## Product Change Notification / ASER-23WWAI681

CCB 4235 Final Notice: Qualification of MMT as a new final test site for selected Atmel AT27C/BV/LVxxxPU/JUxxx products

**Description of Change:**Qualification of MMT as a new final test site for selected Atmel AT27C/BV/LVxxxPU/JUxxx products.

PLCC 32 COVER TAPE (Width: 24mm)

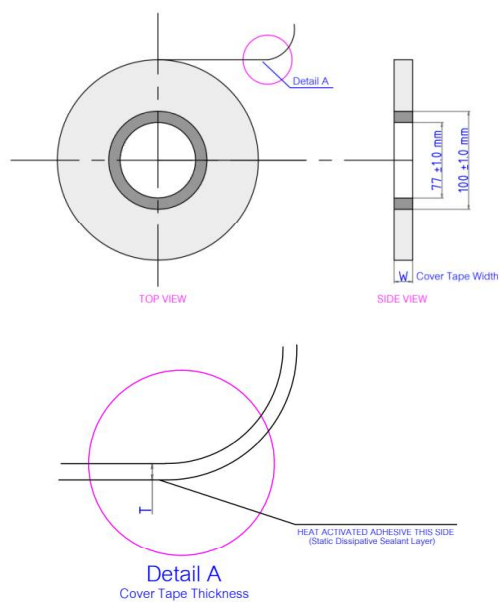
# MMT COVER TAPE

Carrier Width	Supplier	MCHP P/N	Supplier Part	Width "W" (mm)	Thickness (mm)	Sealing Mythology
24mm	Sumitomo	22102002	CSL-Z7302	21.0 +/- 0.1	0.050 ±0.010	Heat Sealing

PLCC 44 COVER TAPE (Width: 32mm)

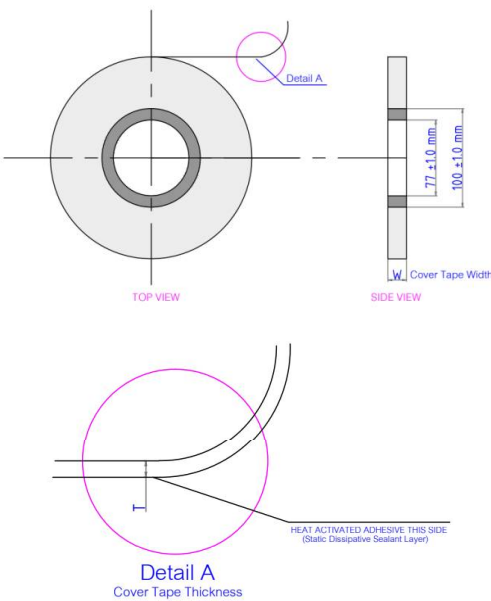
Carrier Width	Supplier	MCHP P/N	Supplier Part	Width "W" (mm)	Thickness (mm)	Sealing Mythology
32mm	Sumitomo	22104401	CSL-Z7302	25.5 +/- 0.1	0.050 ±0.010	Heat Sealing

## PLASTIC REEL: WIDTH 24mm

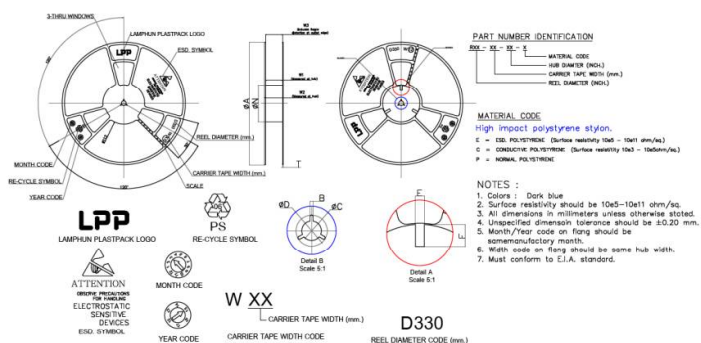
Width	MCHP P/N	Supplier Part	Hub	Color
24mm	23000024	R13-24-04-E	4inch (100mm)	Dark Blue

Description	MPHIL	MMT
Color	White	Dark blue
Diameter	329.99 +/- 1.0	330 +/- 2.0
Hub	100	100 +/- 2.0
Width	25.5 +/- 0.5	24.4 +2.00/-0.00

## PLASTIC REEL: WIDTH 32mm

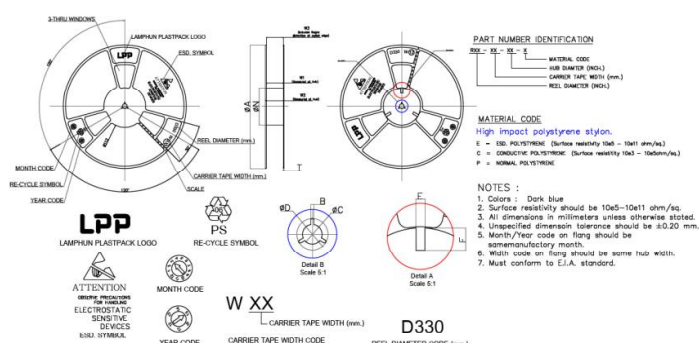
Width	MCHP P/N	Supplier Part	Hub	Color
32mm	23000023	R13-32-04-E	4inch (100mm)	Dark Blue

Description	MPHIL	MMT
Color	White	Dark blue
Diameter	329.99 +/- 1.0	330 +/- 2.0
Hub	100	100 +/- 2.0
Width	33 +/- 0.5	32.4 +/- 2.0
